Addendum No. 2

March 29, 2023

City Project No.: 22-001
Citywide Street Rehabilitation and Improvement Project Package 1

DRAWING No.
SS-07
SHEET:
112 OF 169

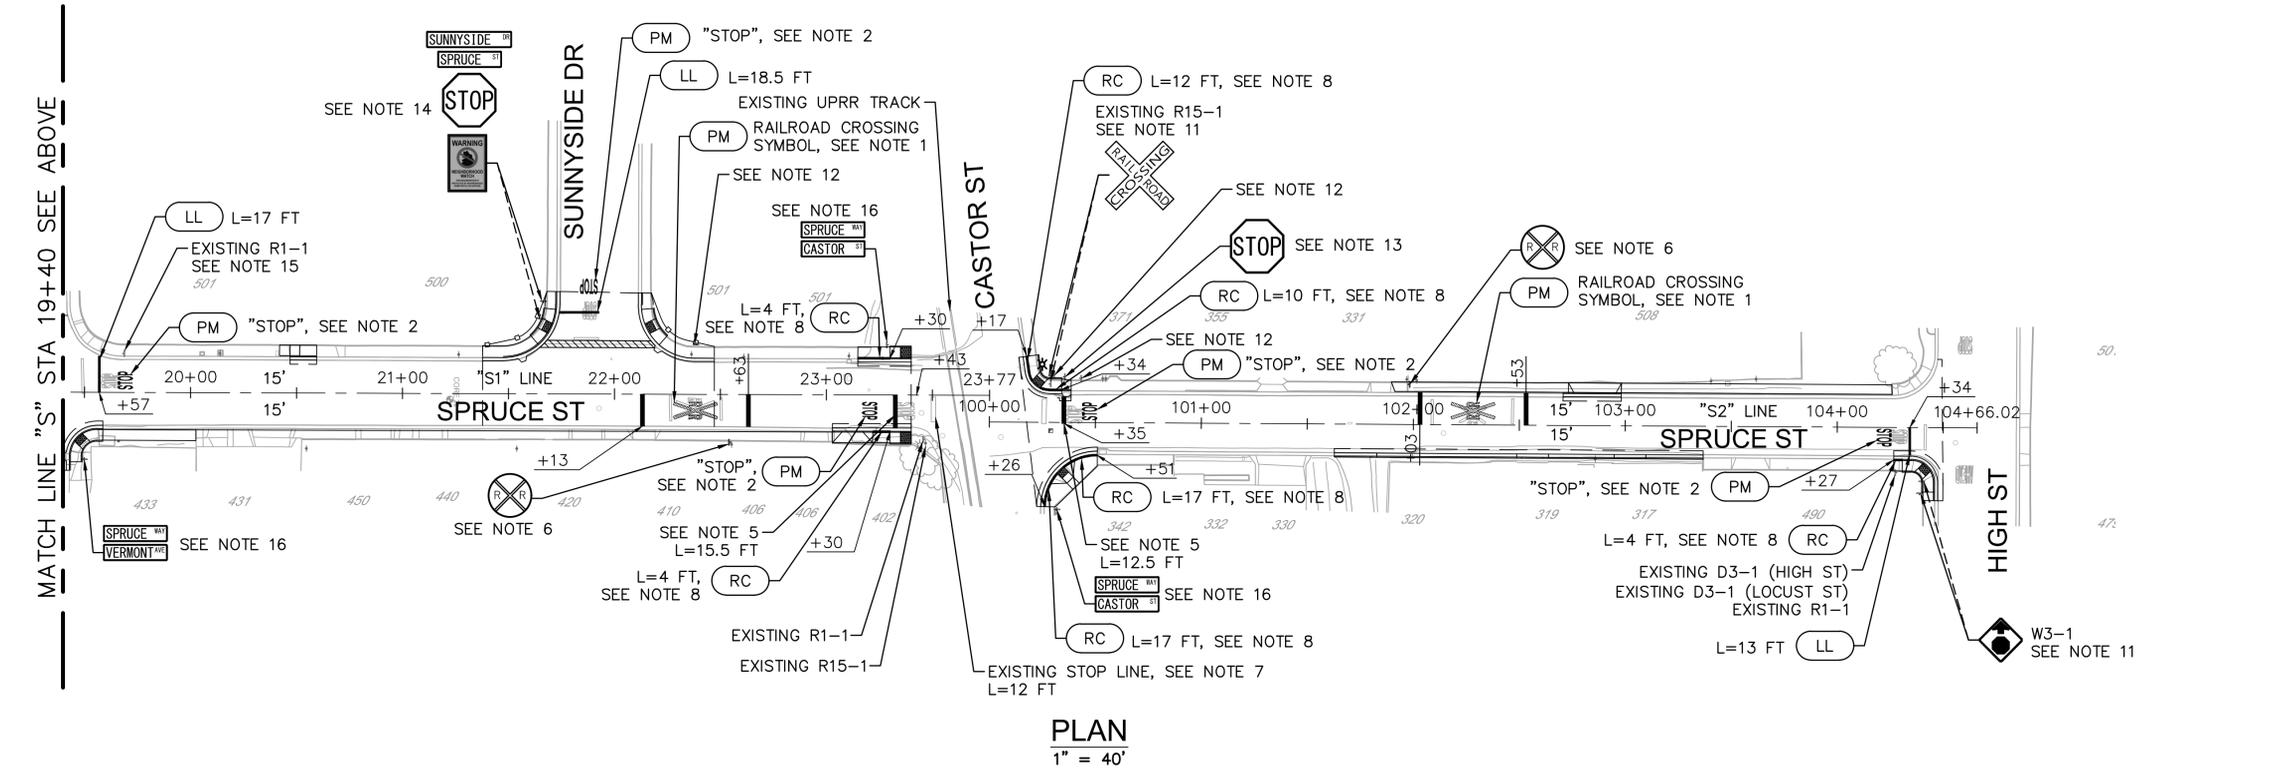
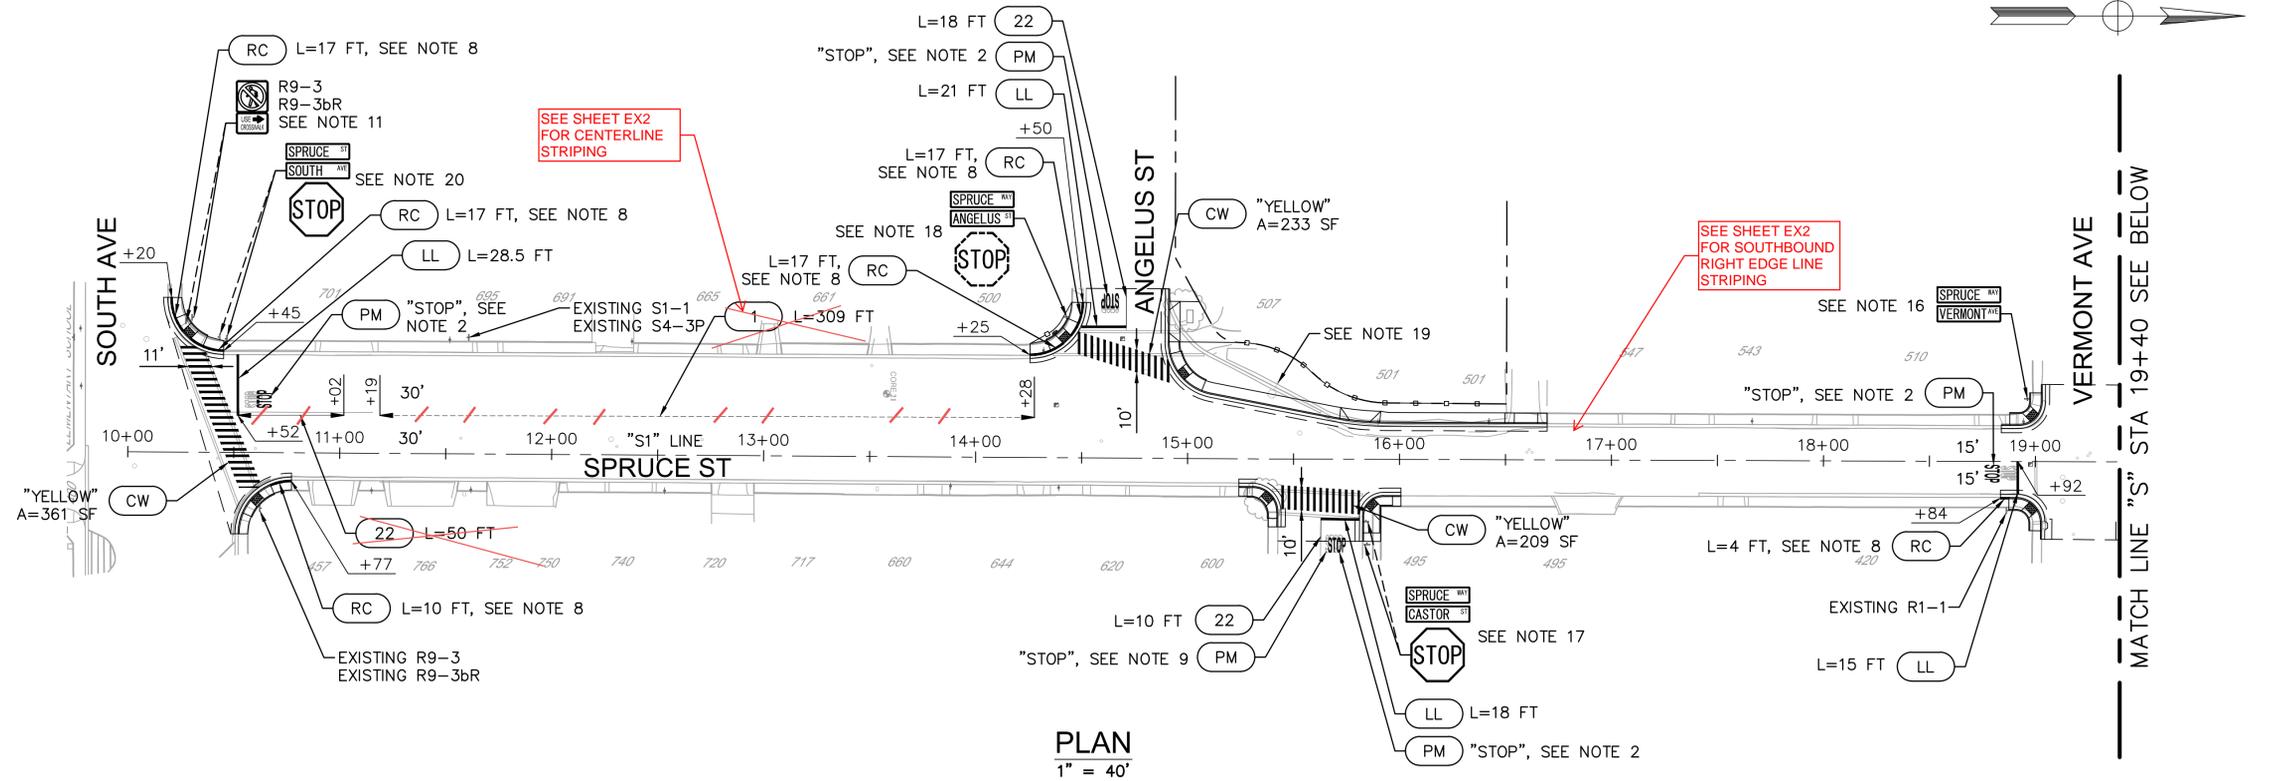
Plan Sheet SS-07 shall be modified as noted on the attached Sheet SS-07 and detail Sheet EX2 that follows.

DRAWING NO.
TR-01
SHEET:
1 OF 1

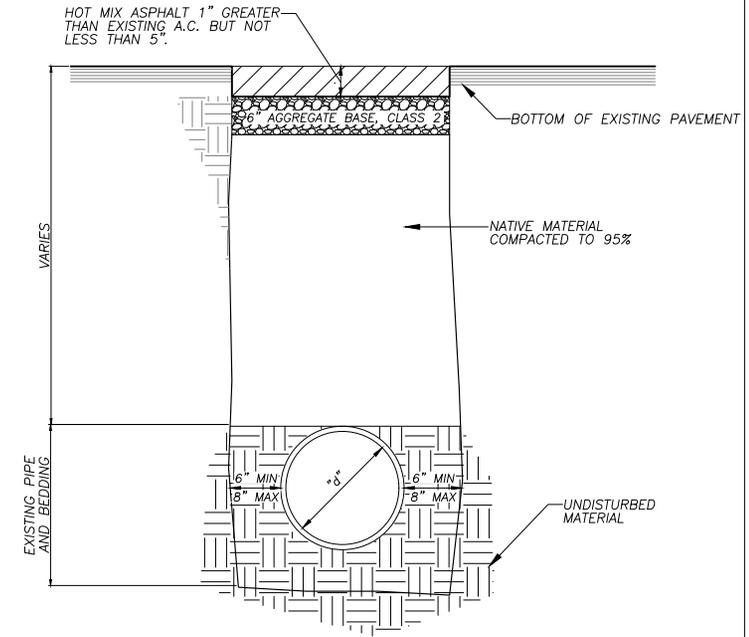
Add the following paragraph directly below Section 10.41 of Special Provisions. The attached drawing No. TR-01 shall become a part of the Project Plans. A new bid item has been added to the Bidding Form for this work.

10.42 UTILITY TRENCH REPAIR

This work shall consist, in general, of: sawcut and demolition of existing pavement; excavating the trench to the top of the pipeline; filling and compacting the trench with native material; installing aggregate base and hot mix asphalt; compaction shall be per the detail provided. Contractor shall remove the trench patch material, excavate the trench to the top of the pipe and back fill the trench with native material compacted as shown in the project plans. For bidding purposes, Contractor shall assume the native material meets the requirements of Structure Backfill as defined in Section 19 of the Caltrans Standard Specifications. Should native material not meet the requirements, Contractor shall provide import borrow that meets the requirements of Structure Backfill as defined in Section 19 of the Caltrans Standard Specifications as extra work paid for by change order. Hot Mix Asphalt (HMA) shall conform to the provisions in Section 10.19. For bidding purposes, Contractor shall assume proposed HMA thickness is 5 inches. Aggregate Base shall conform to the provisions in Section 10.20. Surplus excavated material shall become the property of Contractor and shall be disposed of outside the right-of-way and shall conform to the provisions in Section 7-10, "Disposal of Materials Outside the Right of Way", of the City's Standard Specifications.
